COMMENTS FOR VALLCO SHOPPING DISTRICT SPECIFIC PLAN DEIR

Draft Environmental Impact Report SCH# 2018022021

JUNE 6, 2018

Figure 4: DEIR Heights

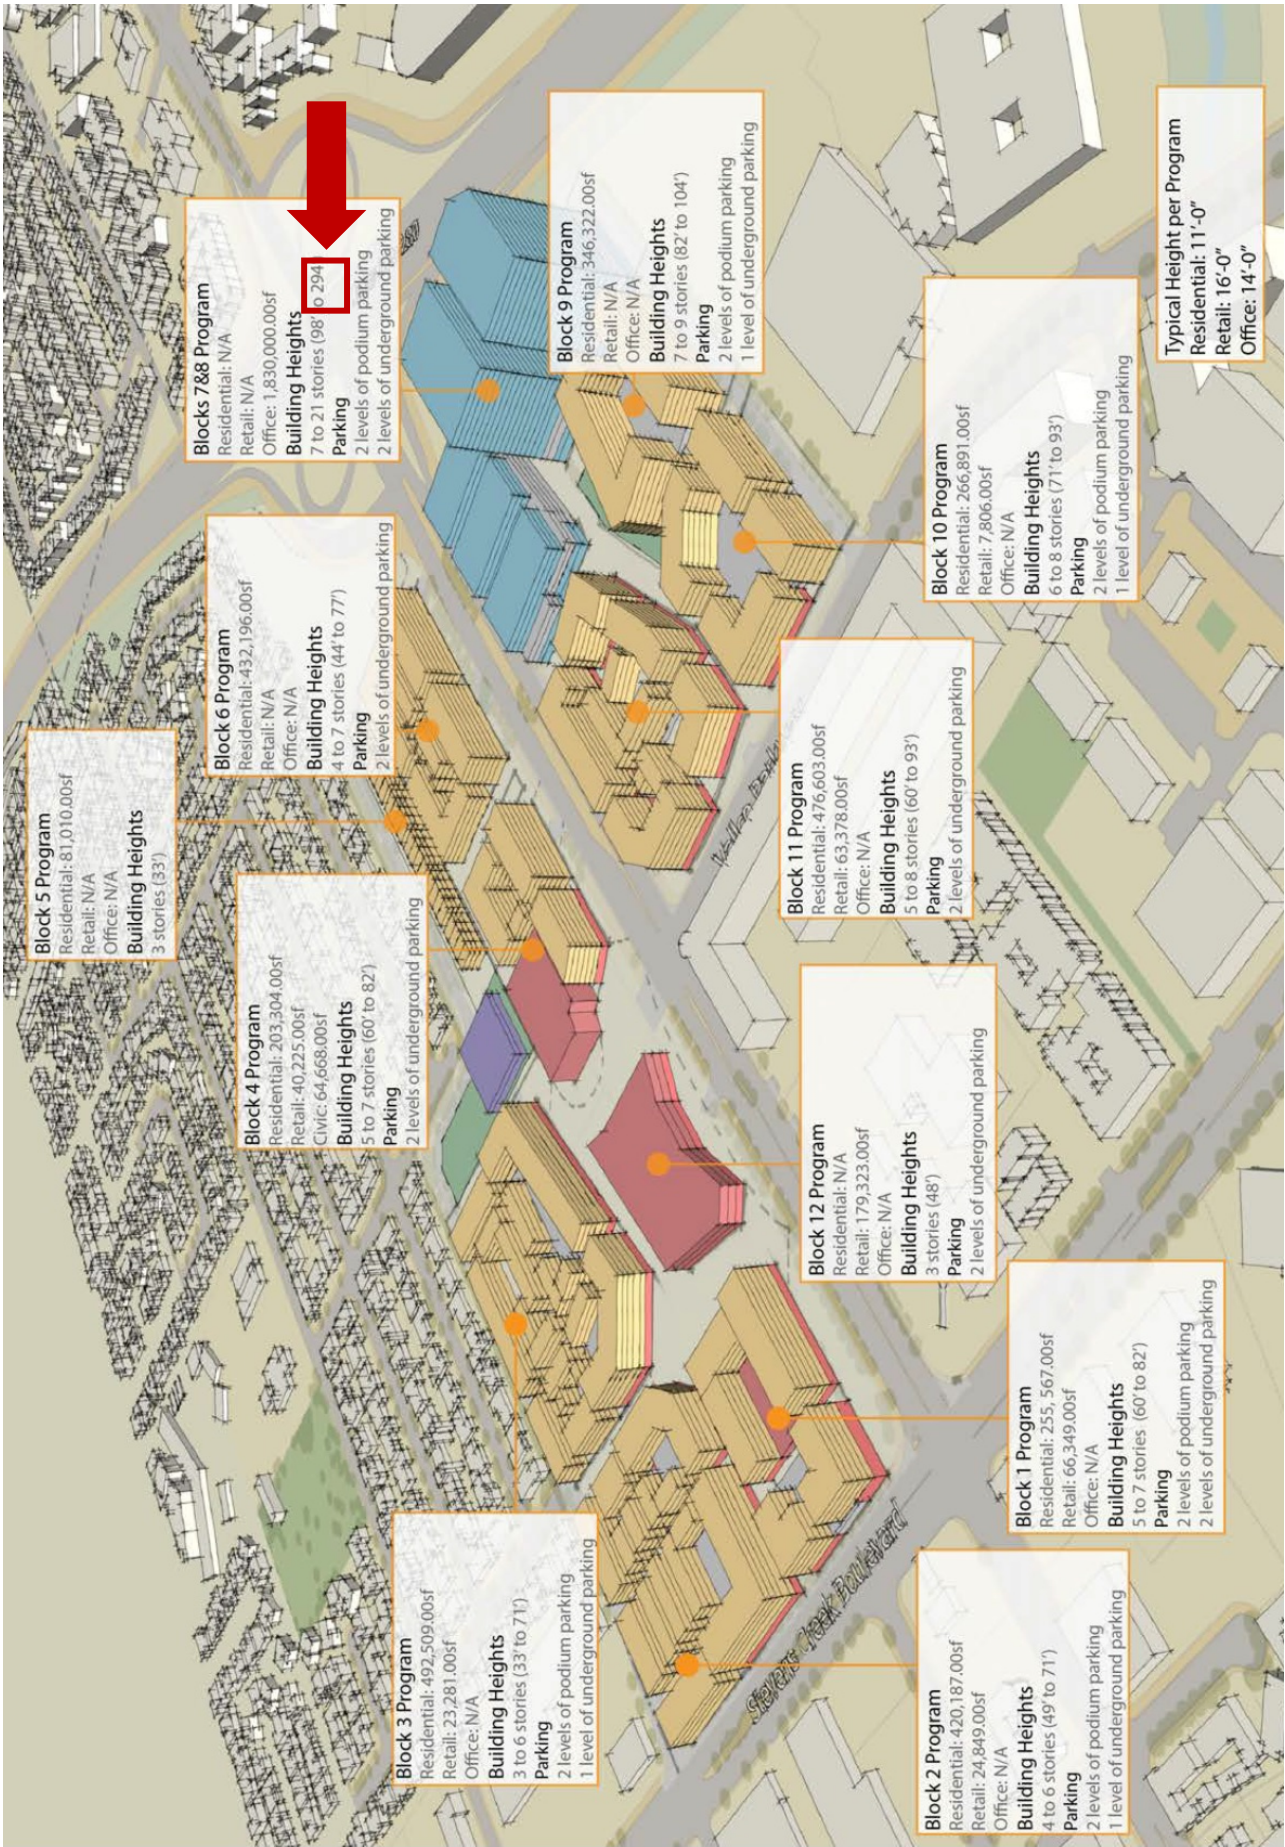
4. To add to the confusion as to what the project may end up being, the maximum height was also shown to be 294'. These height differences will cause different shadow and intrusion issues, such as privacy intrusion into Apple Campus HQ which may be a security risk at the corporate headquarters, guest discomfort at the outdoor swimming pool at Hyatt House, and the lack of privacy for the area homes and back yards. In Section 4.2.1 of the DEIR, heights are shown up to 165'.

Figure 10: Section from SB 35 Vallco Application

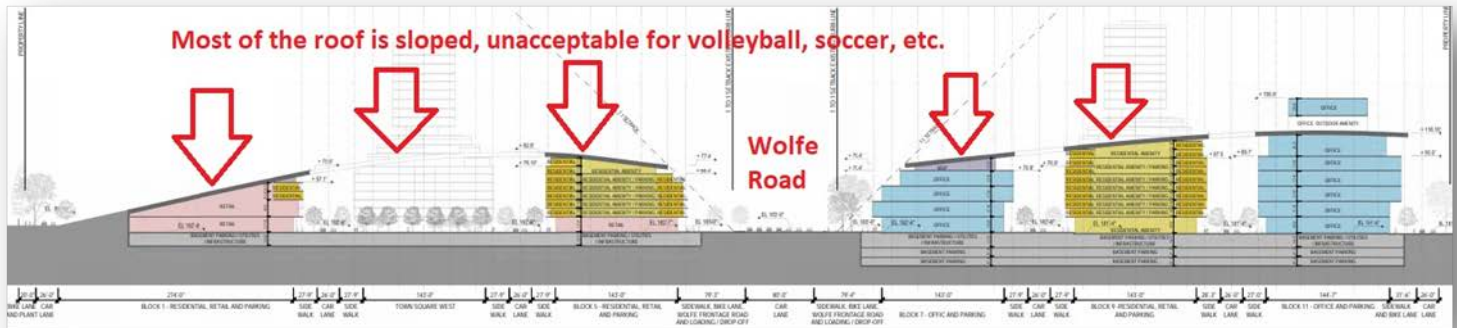
The 30 acre green roof is not park land acreage per the Municipal Code. While it may be considered a recreational area, the uses of such space are limited. Here is a cross section of the SB 35 plan roof:

Figure 25: AQI from BAAQMD

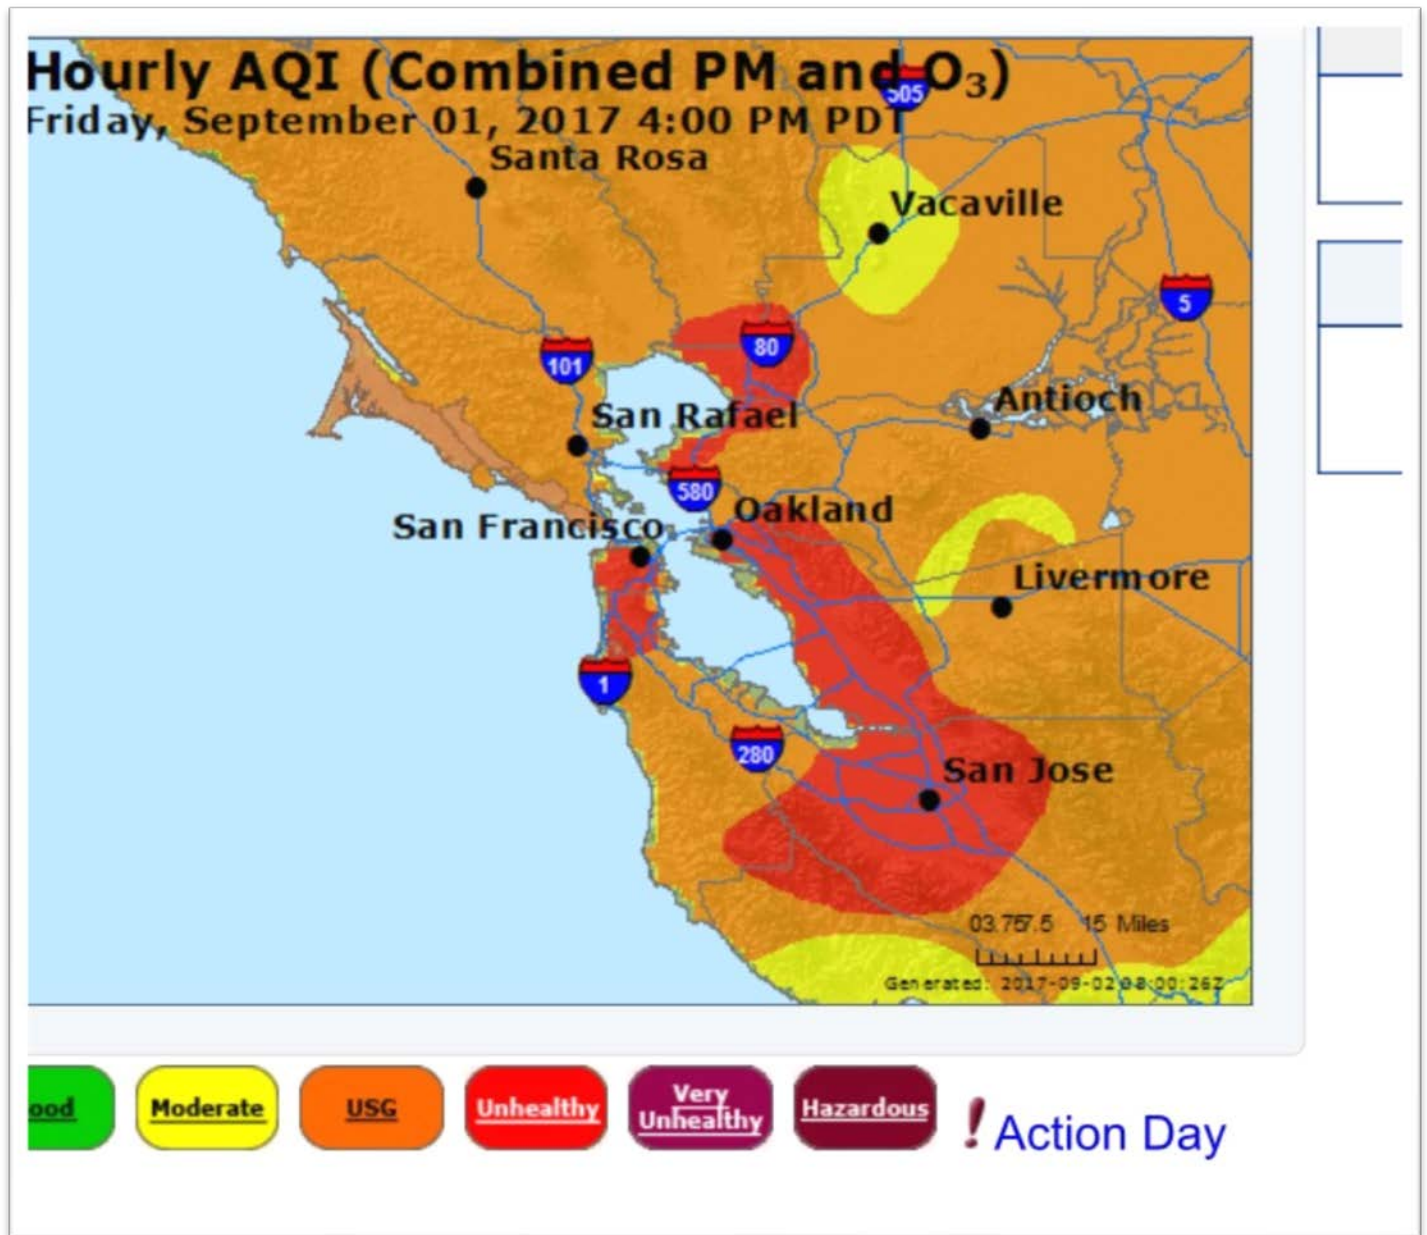
The cancer risk assessment is based on erroneous traffic studies and the air quality monitoring stations had old data from 2013 and/or were too far away to use data. The cancer risk needs to be recalculated. The amount of exposure time should reflect seniors not leaving the project area. The baseline air quality monitoring must be taken over an extended period with particular attention paid to the summer months when Ozone levels increase. Here is an example day when children would be playing outdoors, Ozone was the primary pollutant. Note these are regional amounts, and the increases along the freeways are not shown:

The I-280 freeway produces substantial TAC pollutant concentrations and the south bay is subjected to the entire bay area's pollutants which are converted to Ozone in the warm summer months. The DEIR failed to monitor air pollution for the site for any time period, and only modeled pollutants onsite. Fires are expected to be the new normal, bringing potential further impacts to the region's air quality.

Figure 42: Opticos Charrette #2

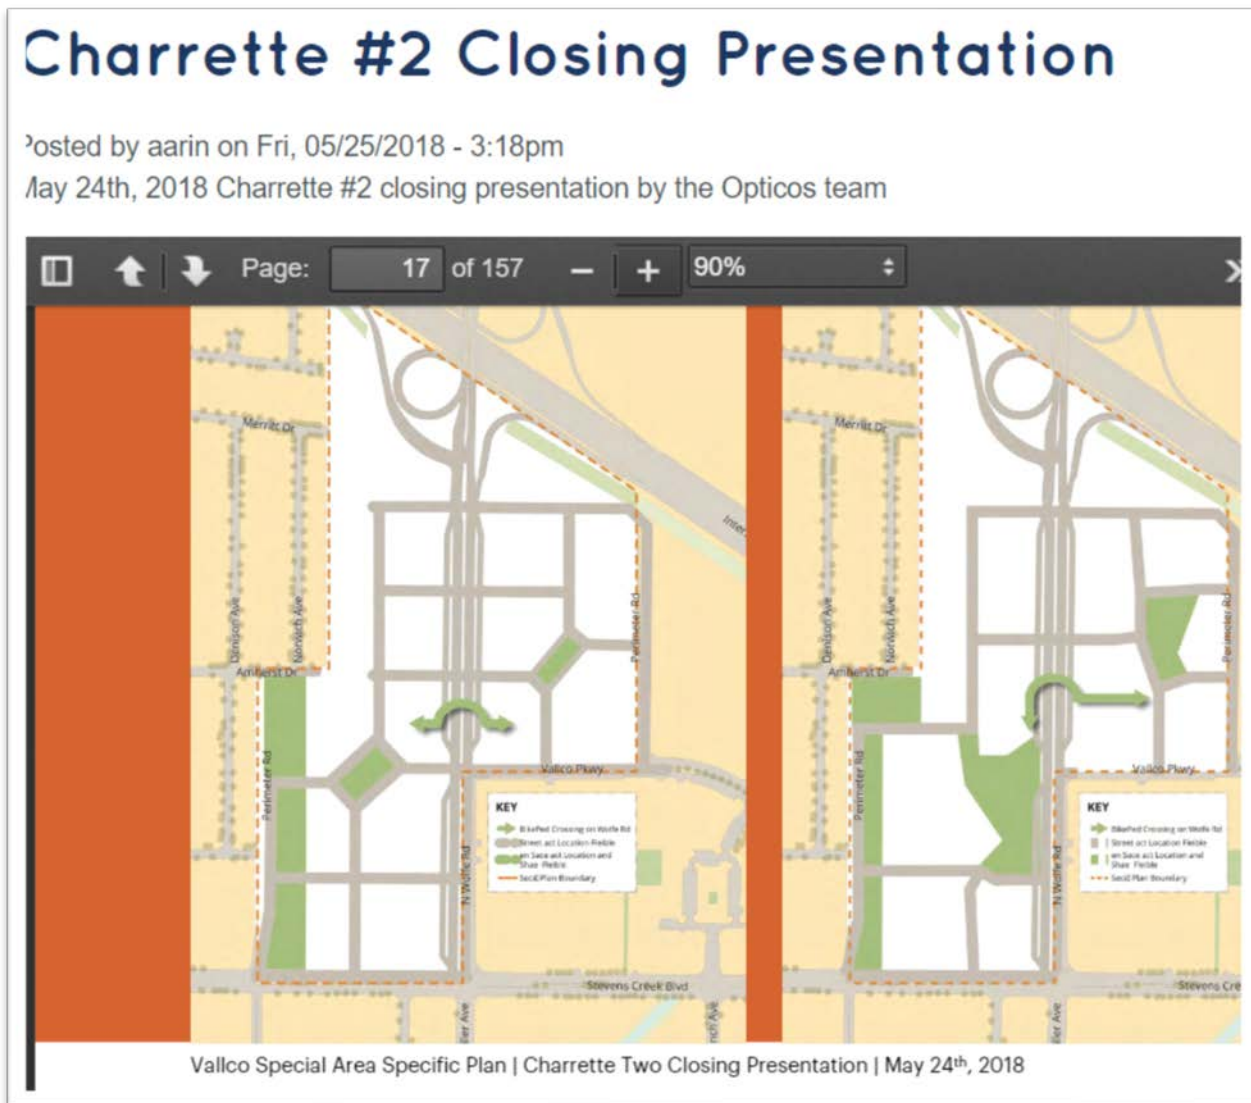
Charrette #2 Closing Presentation shows parks adjacent to back yards of single family residences. This may, combined with Perimeter Rd. noise exceed Municipal Code permissible sound levels. The DEIR does not adequately address this.

FIGURE 3.13-2

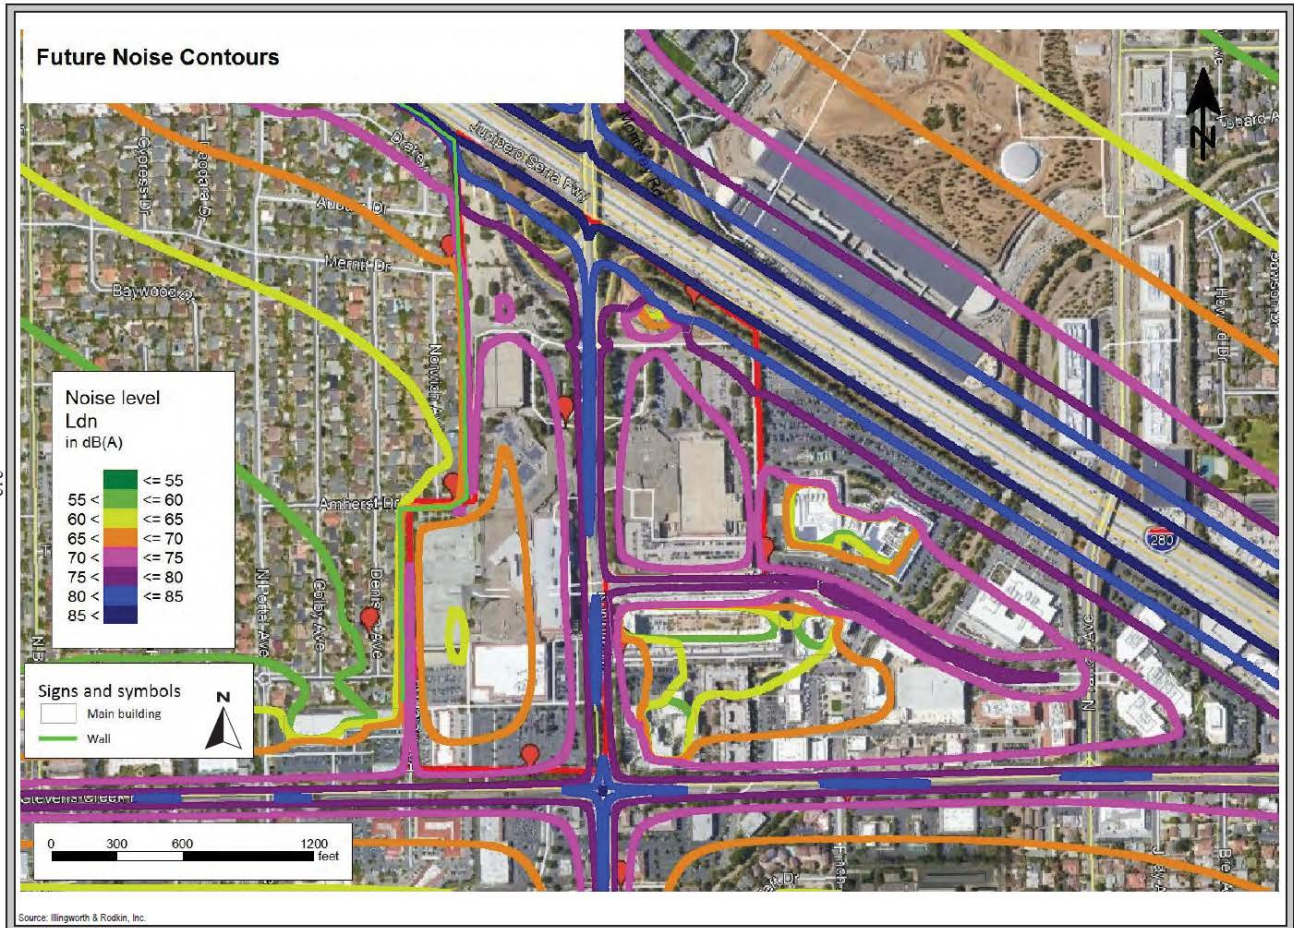
The Future Noise Contours map has some omissions regarding noise from the Perimeter Road, western edge park, and proposed amphitheater. The map has gross assumptions regarding what the plan would look like and ignores conditions on the roof which would result in a separate layer of mapping: One layer for ground level (ear level) and one level for the roof park to see if it meets park noise requirements.

The future noise contours for the project site exceed residential maximum levels according to the Cupertino Municipal Code 10.48.040.

Figure 52: Sample of local advertising showing higher employees per 1000 SF than studied

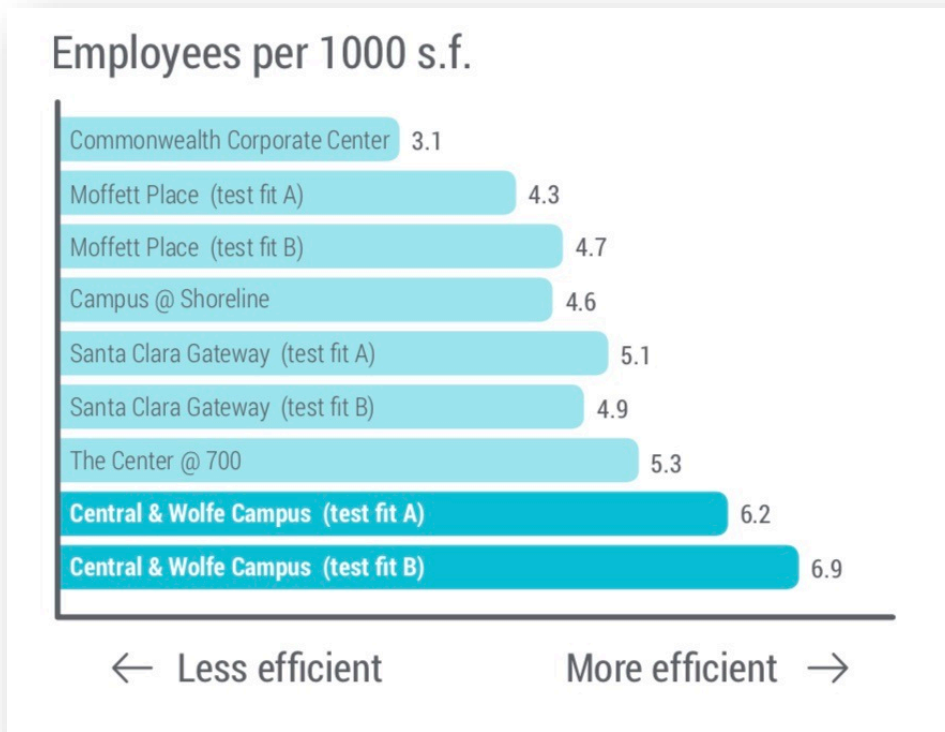
It is unclear, given that Apple Park has been occupying, how their (Apple Park) traffic has been assigned. For instance, there were traffic counts in May, 2017 which would reflect thousands of trips by construction workers to the site which would likely have been coming from the I-280 and east bound AM and westbound PM. There were also traffic counts in January, 2018, which would perhaps now show a few hundred Apple tech workers who would presumably be coming from other areas along with continued construction workers. As of March, 2018 approximately 6,000 employees were at Apple Park out of the expected 14,200. There have been many requests of the city to wait until Apple Park fully occupies to perform traffic counts. Main Street Cupertino was also under construction during May, 2017 and those construction workers would also be impacting the counts. There have been several intersections under construction, including the Calvert/I-280 project and Lawrence Expressway/I-280 exit project. These multiple projects have rerouted traffic and altered the makeup of drivers into artificial patterns not reflected in the study. What the traffic counts show, is what the area traffic is like with major construction underway.

Traffic impacts, while significant and unavoidable with mitigation is underestimated.
